Flight Procedures Cover Page	Task Action: FLIGHT CHECK	Task Type: Segment	Estimated Chart Date: 01/22/2026	APWS Task ID: 4AFFE9EA90FF458BB9615CD2624D373B	APWS Project ID: 2C75217C1D12473C9AEE06E1C150F0E5
Procedure: V12 MIROY, PA TO HAR VORTAC, PA		Enroute: YES	Specialist: Johnsen, Daniel		Agreement Number:
Airport ID:			Airport City:		State:
Facility ID:	Facility Type:	Flight Inspection Remark Type: New FC Slot			
<div>Procedure Comments:</div> <div>Airway Starting Point: MIROY, PA 401855.72N/0782126.70W.</div> <div>Flight Check: Request to validate JUNEY and POLLS facility make-up change from JOHNSTOWN (JST) VOR/DME to HARRISBURG (HAR) VORTAC.</div> <div>Cancels NOTAMs FDC 4/0336, 4/0338.</div> <div>Contact Casey Hill, AJV-A421, (405) 954-0624.</div> <div>QUALITY 13 CHECKED</div>

V12 (1 OF 2)
JST VDME - HAR VTAC
SCALE 1:500,000

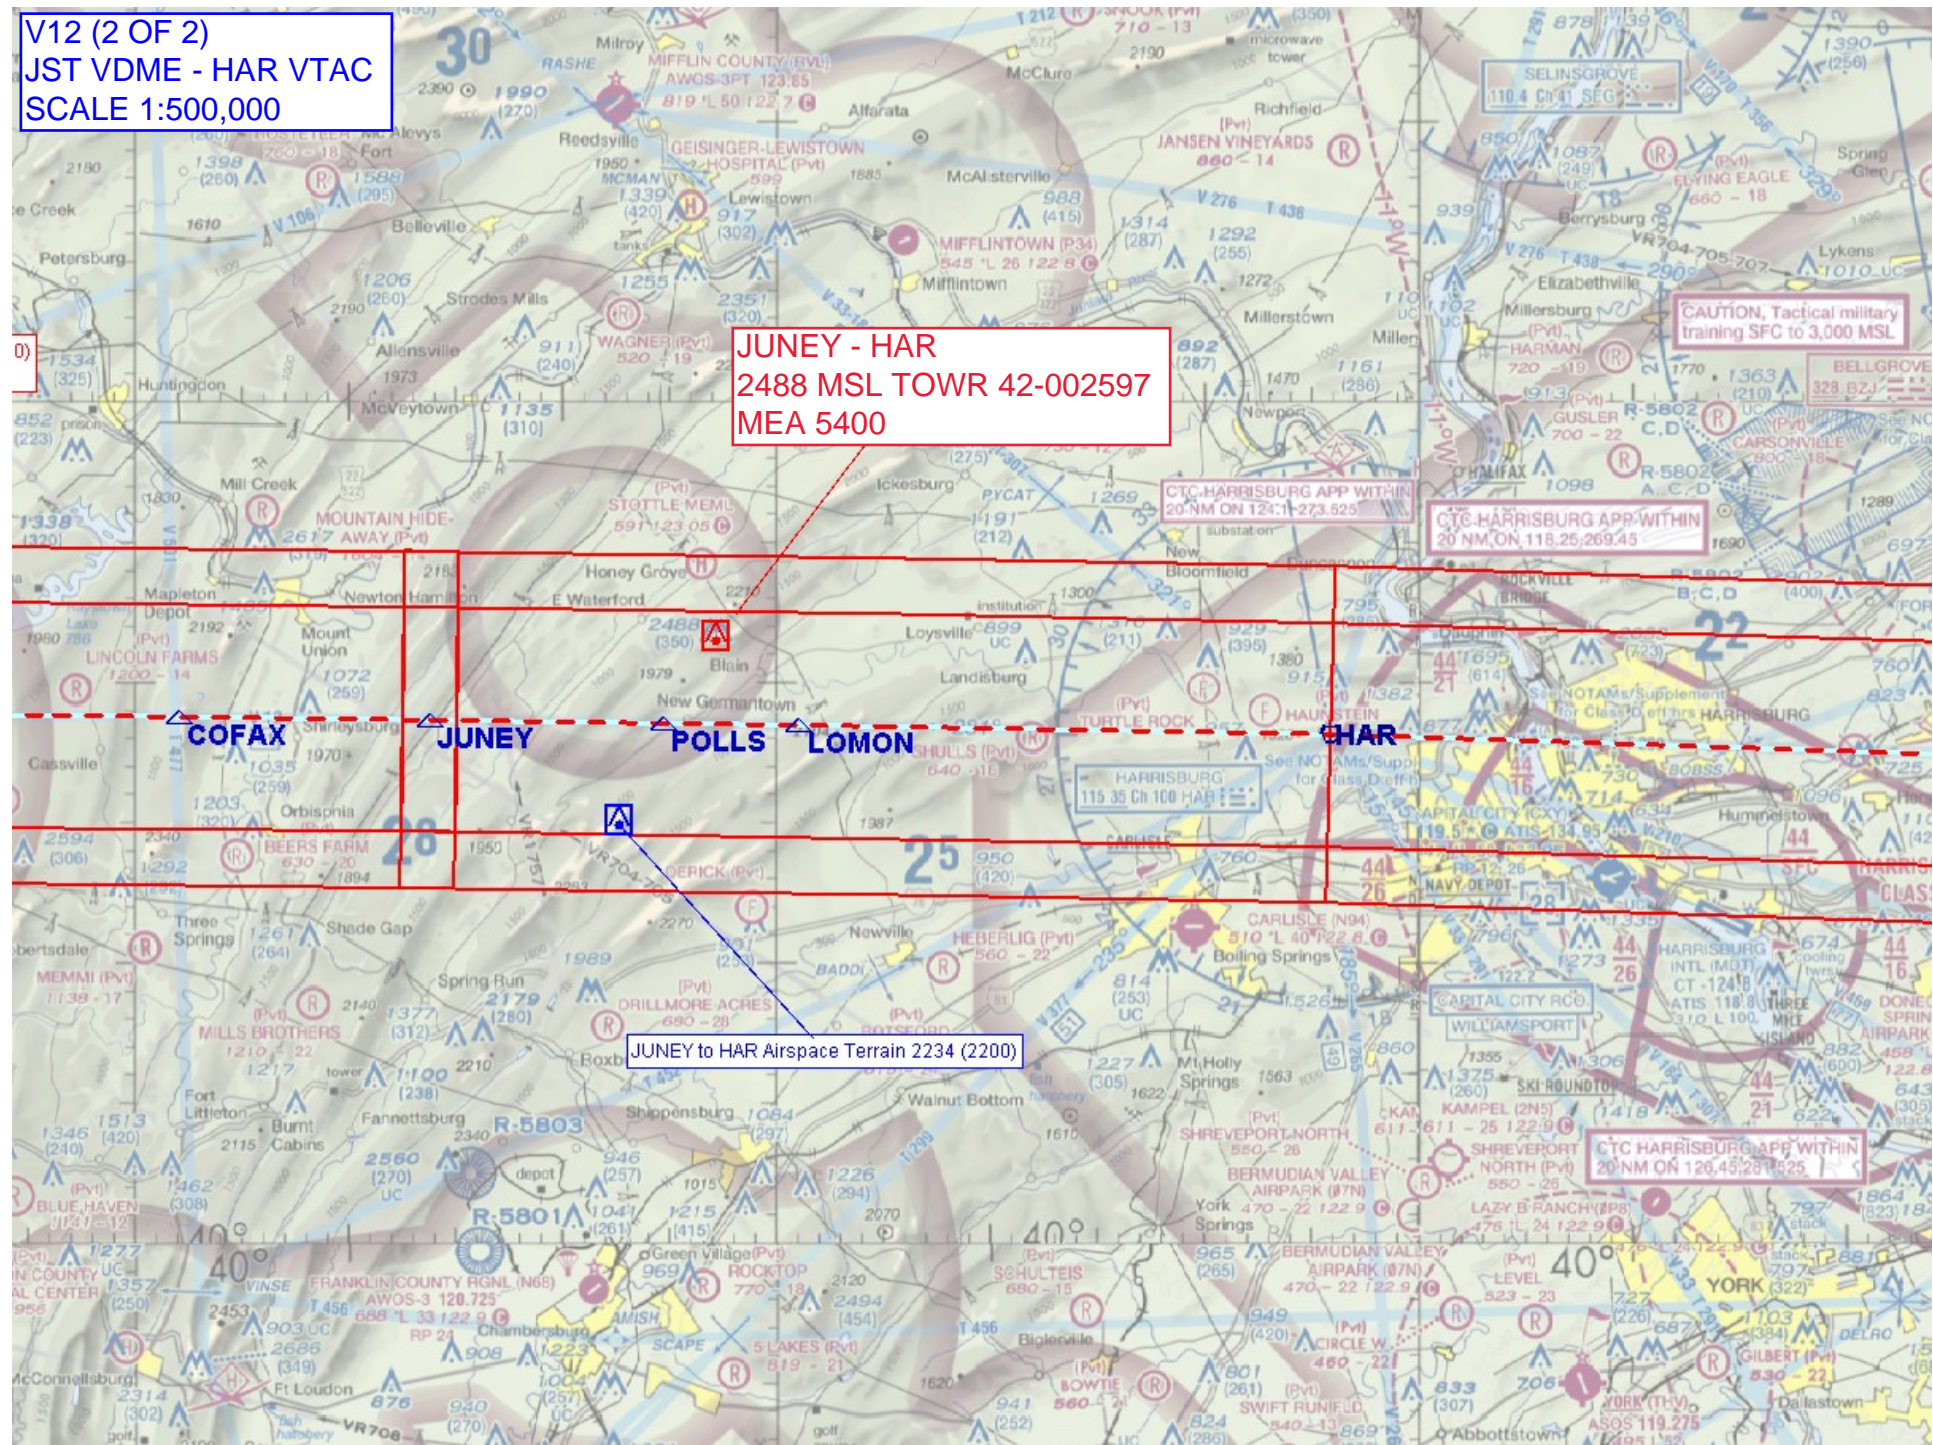
MIROY - JUNEY
SEGMENT UNUSABLE

Extend unusable segment to JUNEY
